Village of Thiensville
Plan Commission
AGENDA

DATE: Tuesday, June 11, 2024

**GILMAN
413 OAKWOOD
BACKYARD SHED**

To: Thiensville Plan Commission

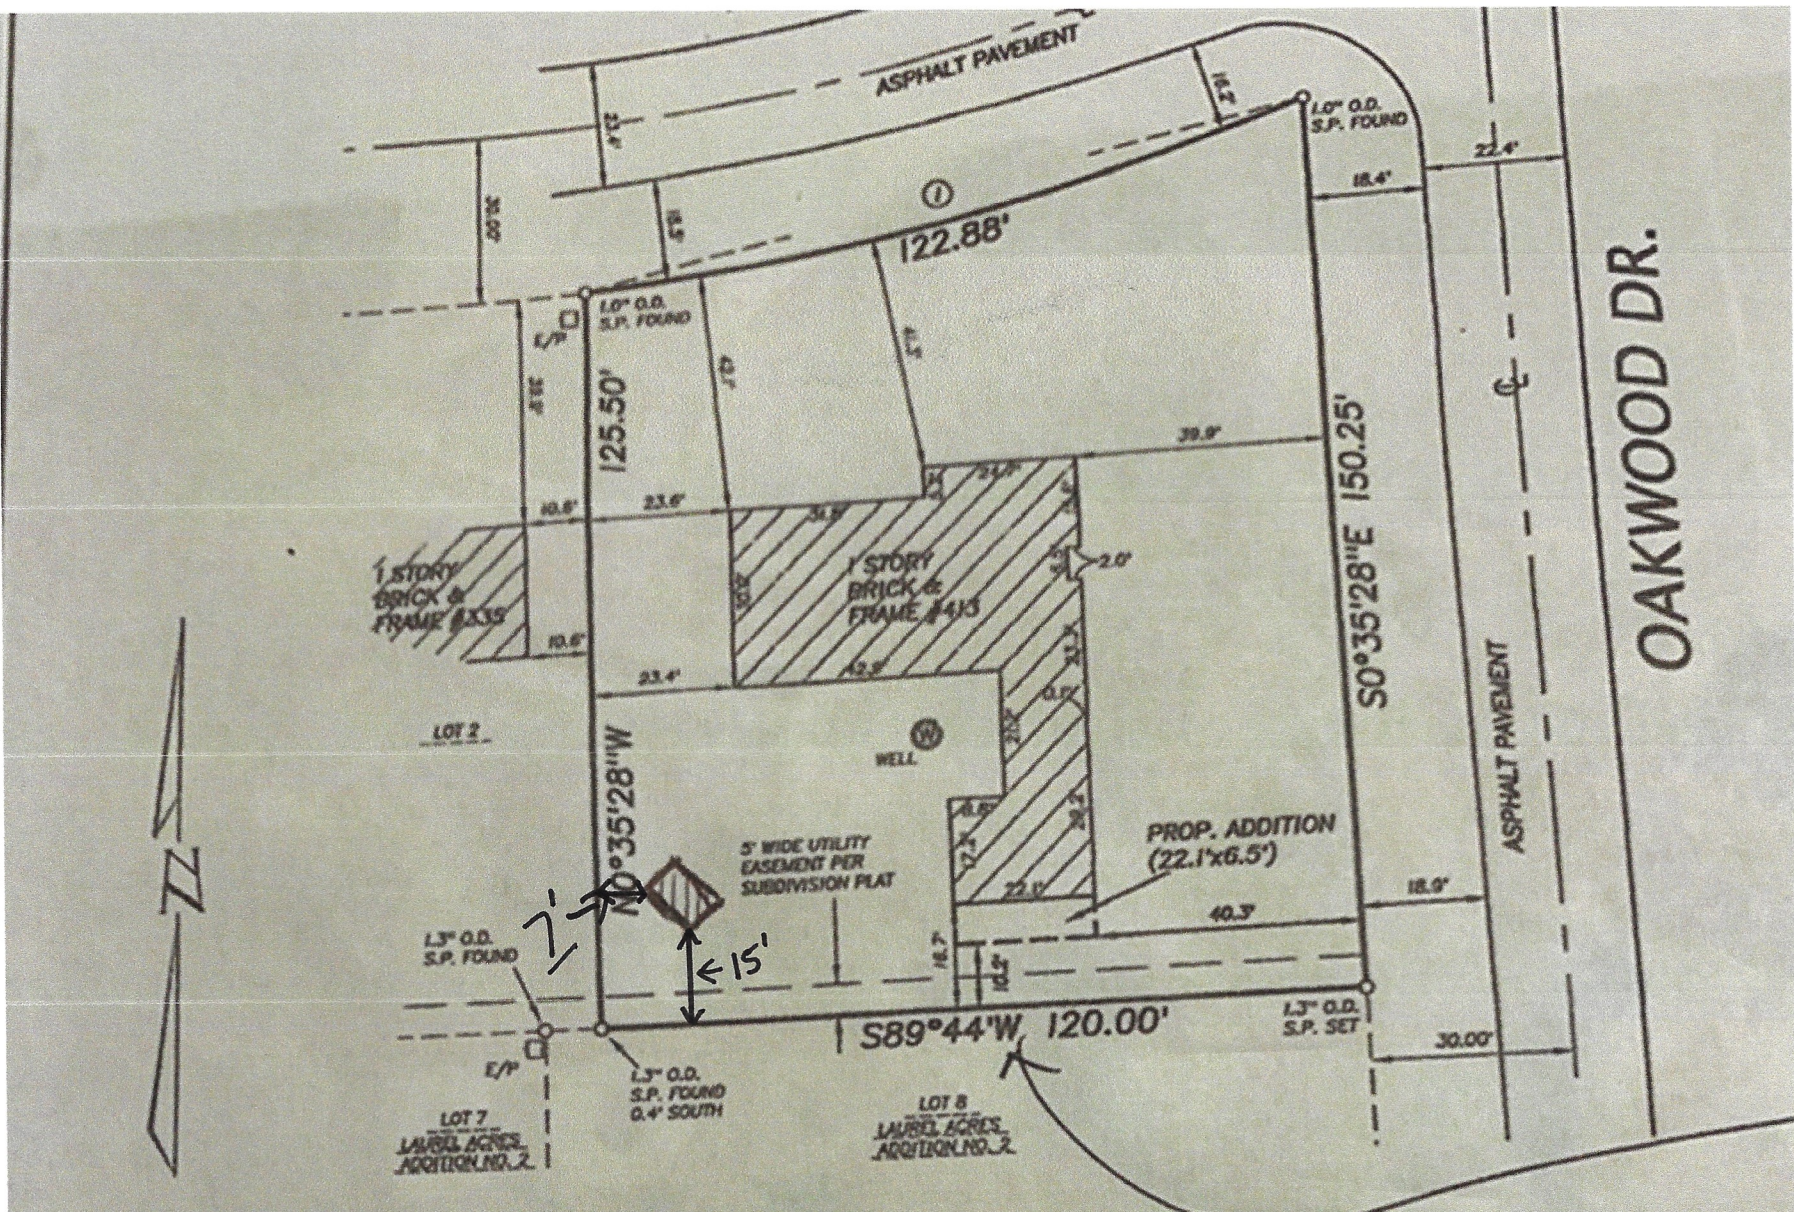
The applicant is proposing to install a backyard shed to be located 15' off the rear property line and about 7' west of the west property line. The structure will measure 8'x8' for a total of 64 square feet in size and at 9'2" will be under the 12' height limit. The shed will have a single door and attractive windows. The proposed shed will have grey siding with white trim and premium dimensional shingles

Staff's review indicates full compliance with the R-1 requirements that therefore approval is recommended subject to the following:

- The applicant secures a building permit prior to construction.

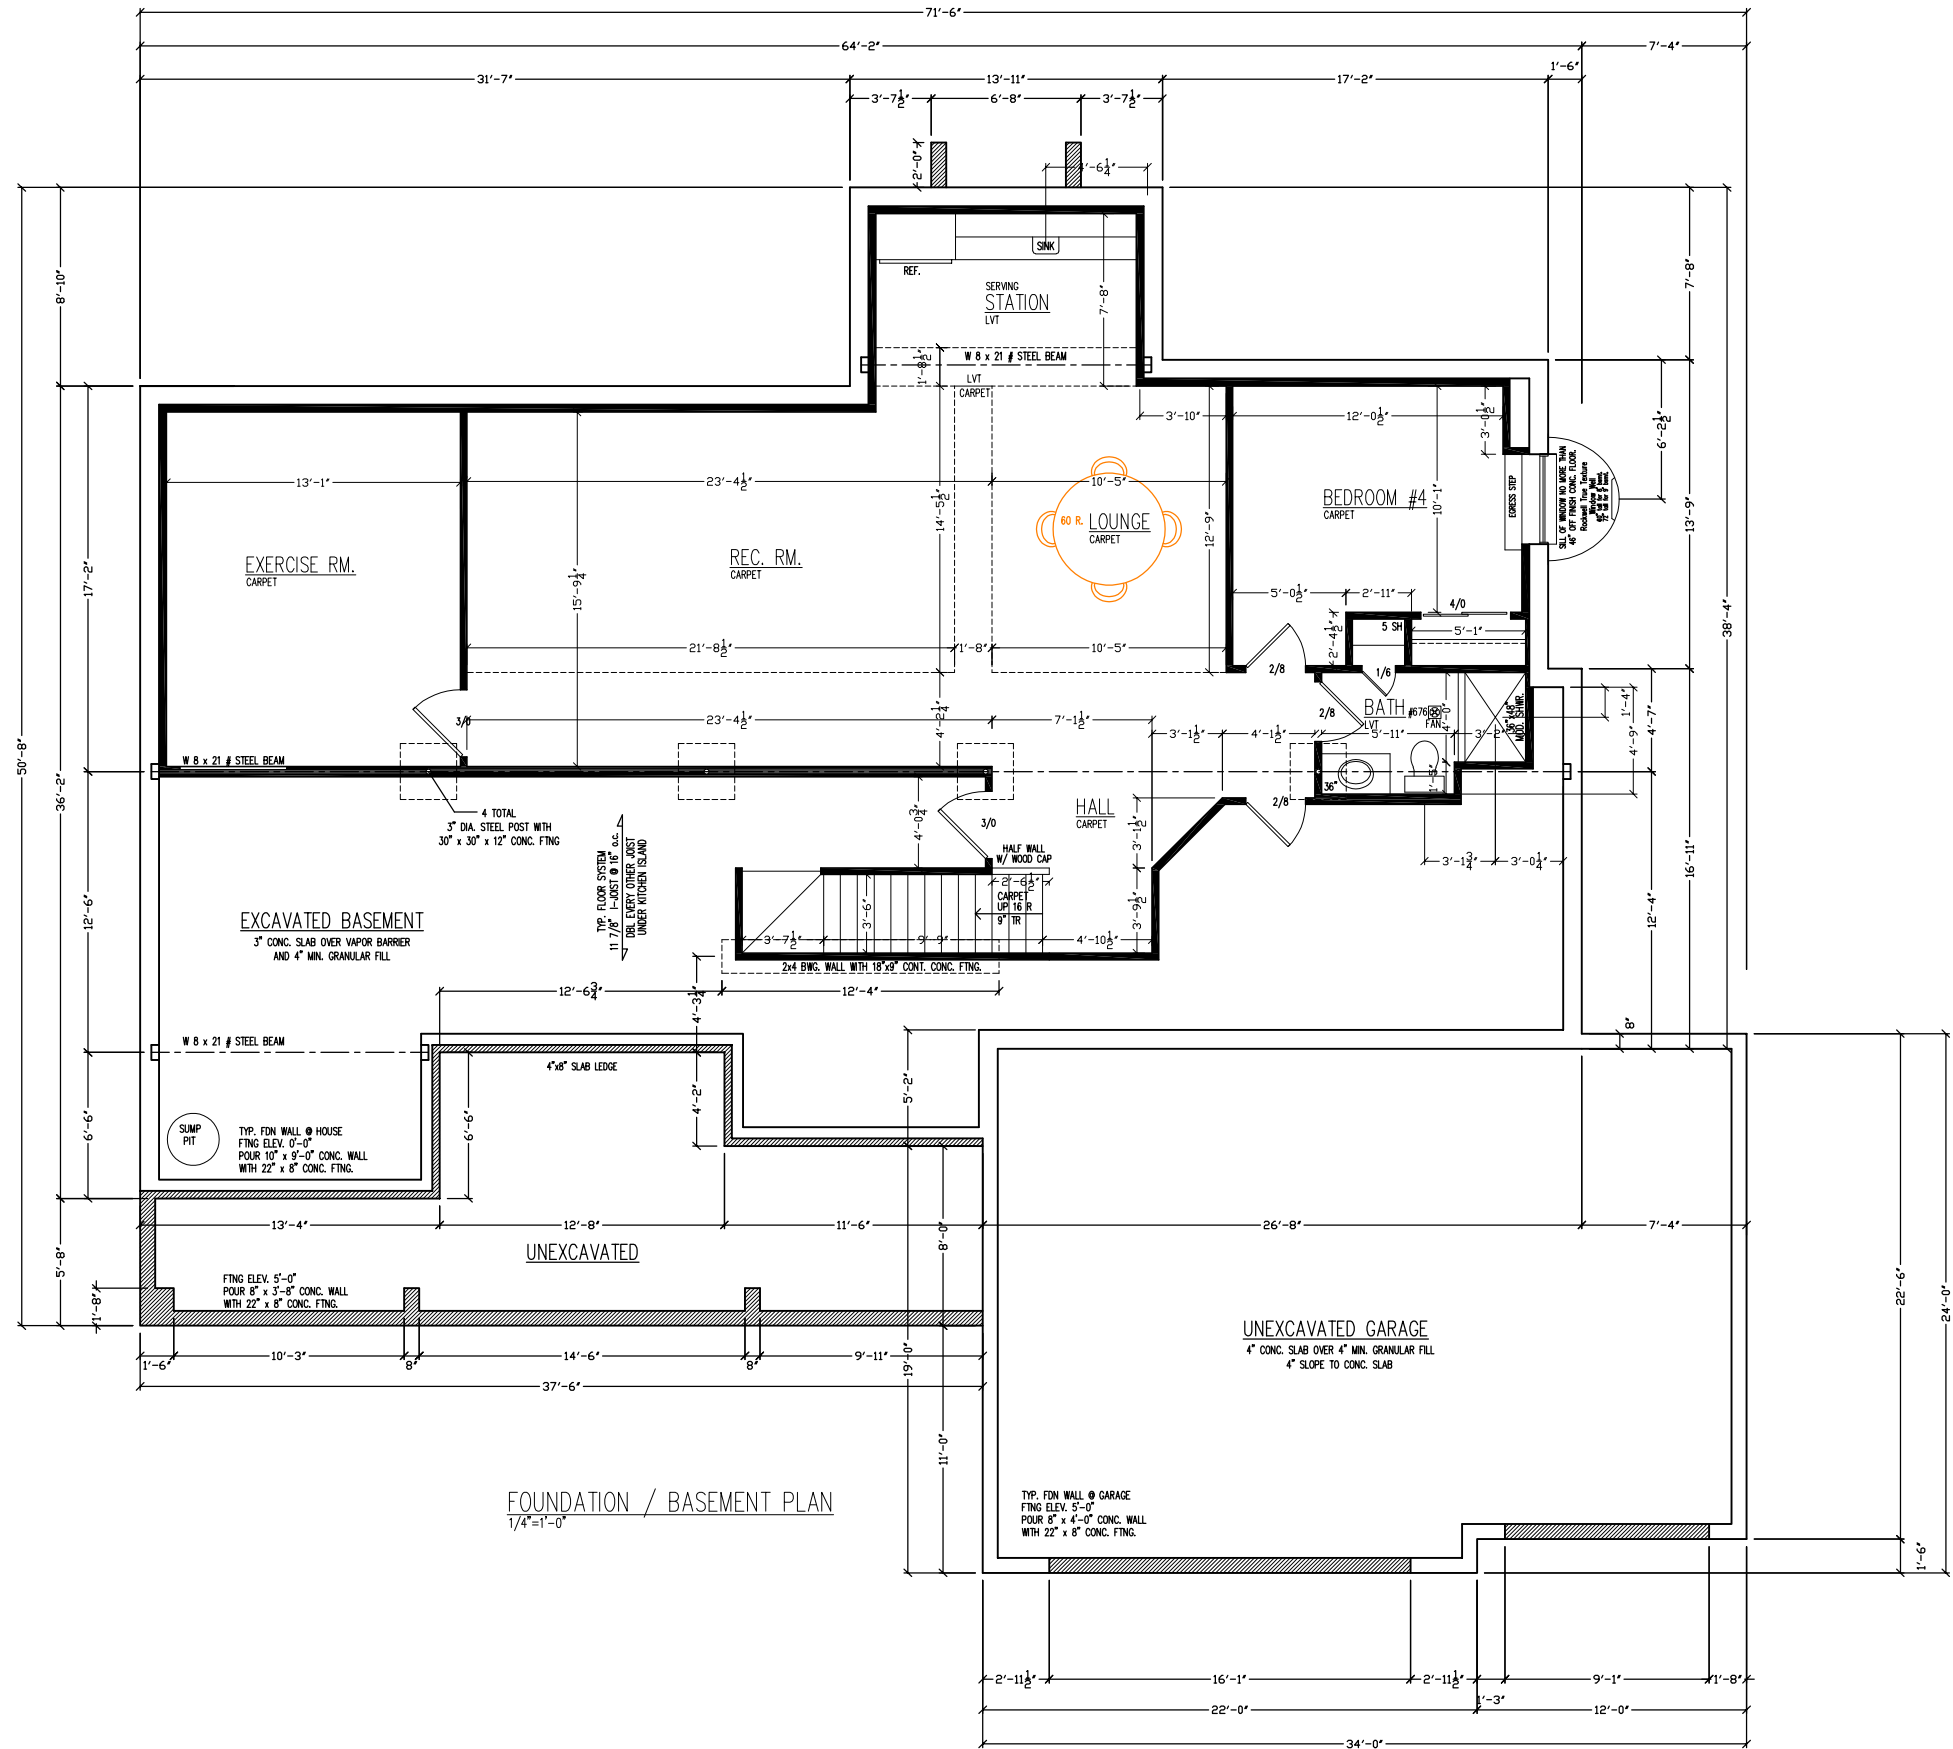
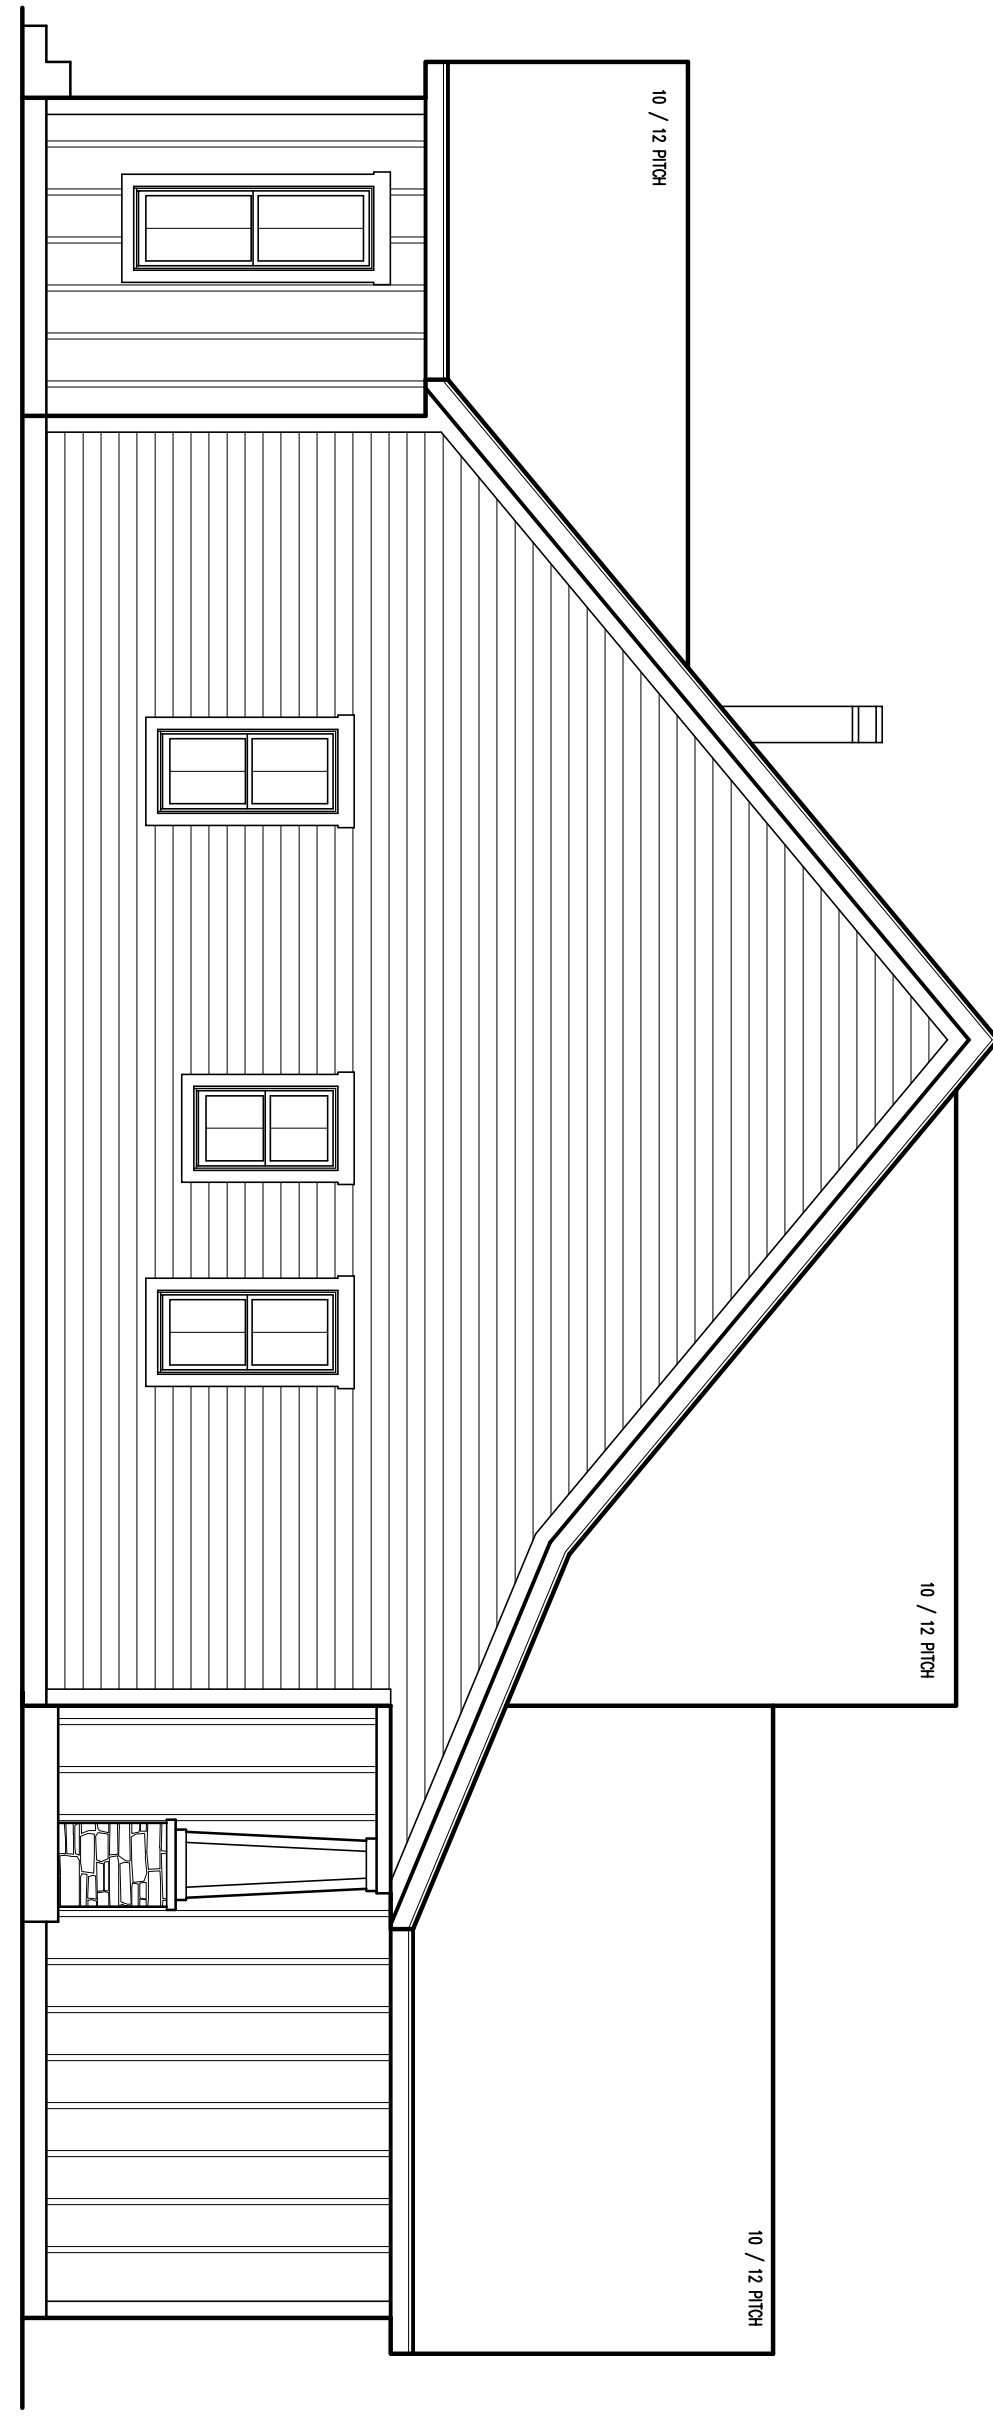
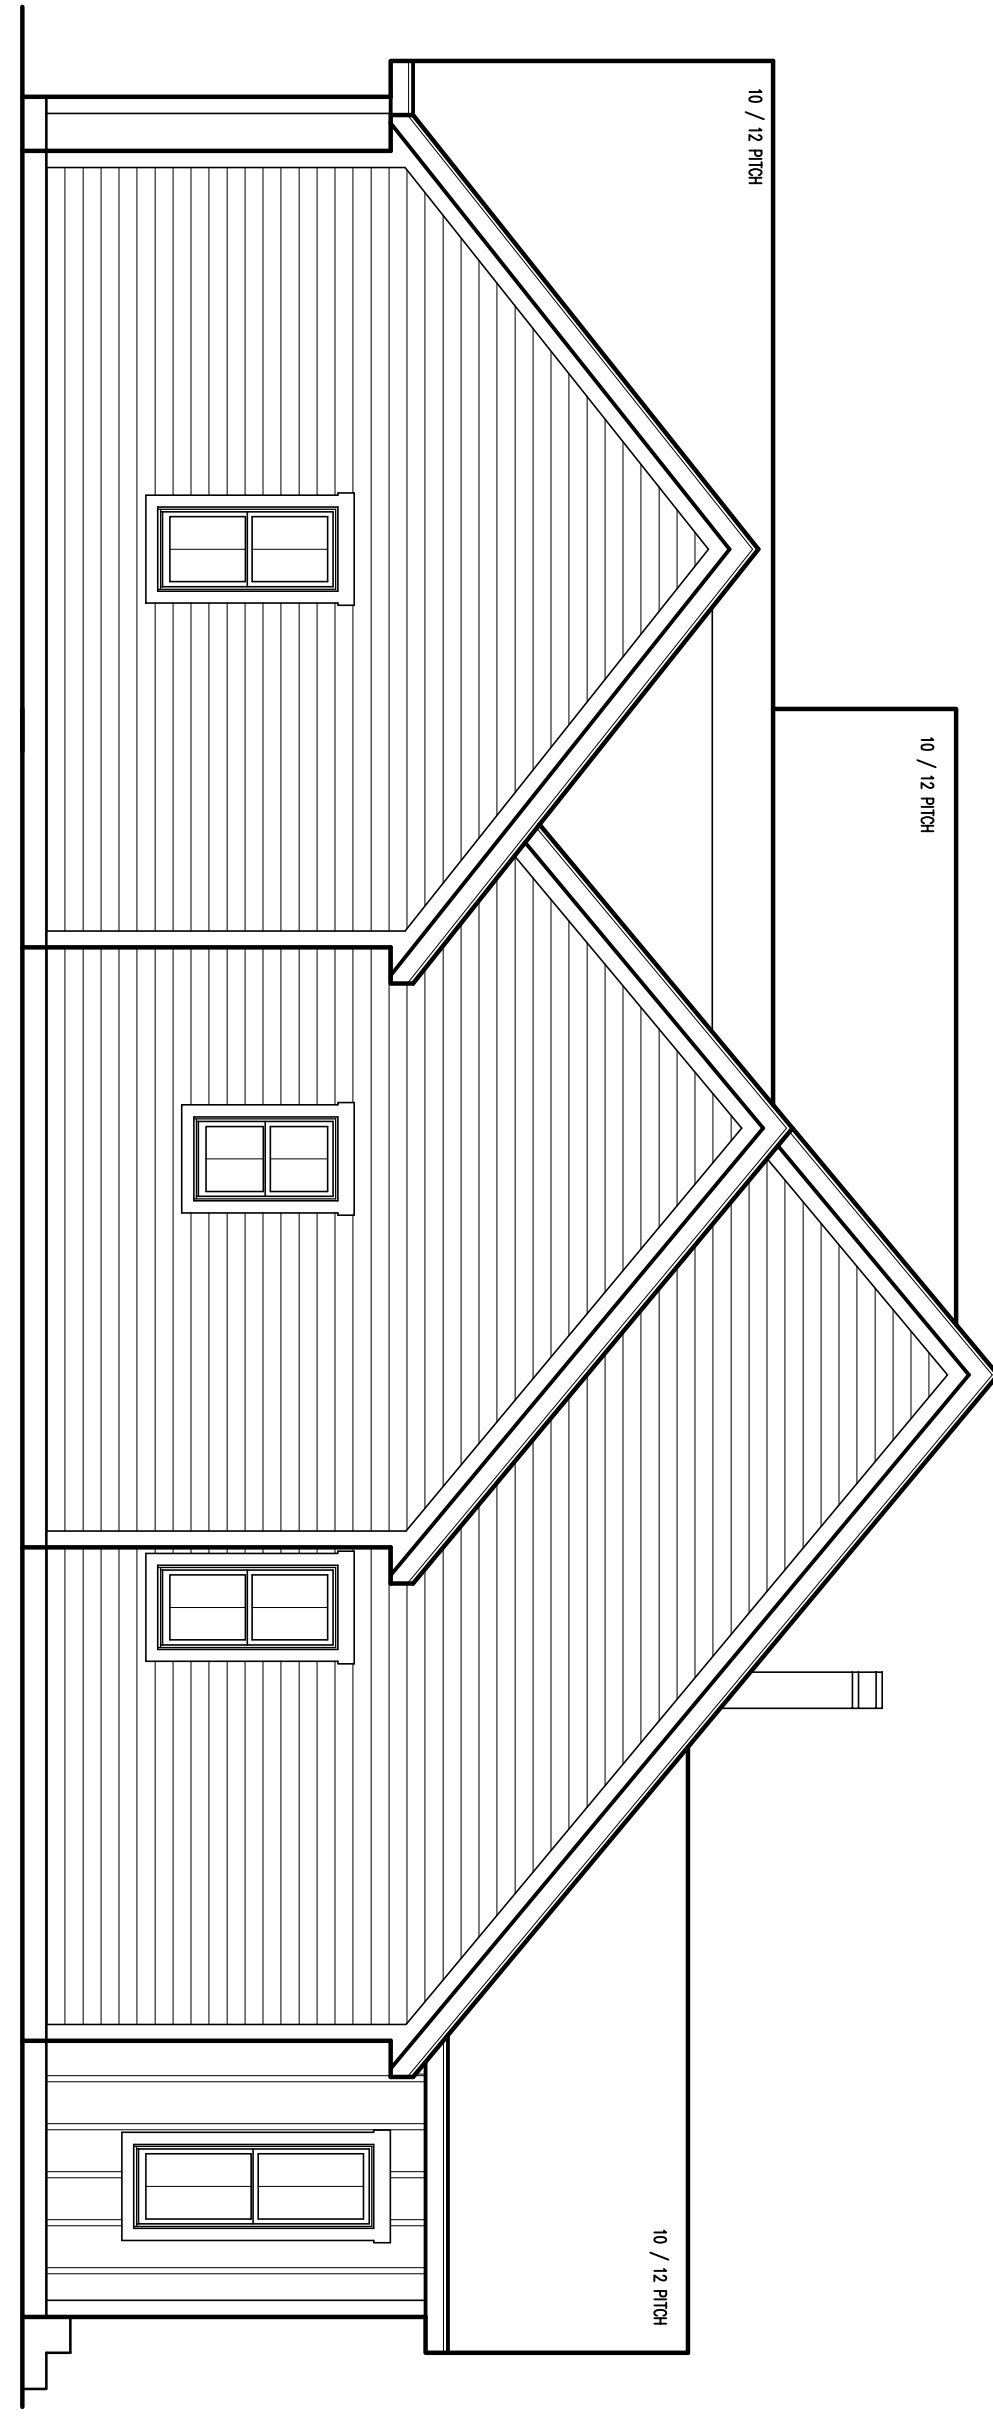
The applicant is requesting approval of house plans for a single-family home designed to look like a modern farmhouse for the currently vacant lot at 624 Green Bay Road. These plans propose a 3,290 square foot house that meets and exceeds the setback requirements of the R-1 District. The table below compares the R-1 zoning districts yard and height requirements and the plan's proposed dimensions.

Yard/Height Requirement	R-1 Standard	Project Plan
Minimum Building Area	1,200 sf	3,290 sf
Minimum Front Setback	40 ft	50 ft
Minimum Side Yard	10 ft	11.7 ft
Minimum Rear Yard	25 ft	80.9 ft
Maximum Building Height	35 ft	27.1 ft
Total Lot Area	13,500 sf	1,9121 sf

The submitted elevations and building plans show a three-car garage, with a double and single garage door, facing front toward Green Bay Road. The driveway will provide street access and is designed within the side setbacks as required by the code.

The plans show an attractive home single-story home with a basement and a covered front porch with a mix of building materials and colors that will be compatible but not repetitive of surrounding homes. Building materials include vertical board and batten siding, traditional cement board siding, stone, and

wood with enamel roofing covering the porch area. The home generally meets the single-family residential architectural review guidelines, however, the front facing garage is somewhat contrary to the guideline that, *“(5) New housing development shall avoid front elevations, which mainly consist of rows of garage doors.”* While many older homes along Green Bay Road have front facing garages, many of the newer residential developed homes include side facing garages. It is to the Plan Commission’s interpretation and discretion to approve the plan as designed with the front facing garage.

Landscaping plans were not included with this application. It appears that the home is being built prior to securing a buyer/occupier who may have input on the landscaping of the project. The report will recommend that a landscape plan, as required by the code, is provided prior to the project’s occupancy.

- Director of Public Works review and approval of the grading, drainage and erosion control plans.
- Provision of an approved landscape plan prior to occupancy.
- The applicant secures a building permit prior to construction commencement.
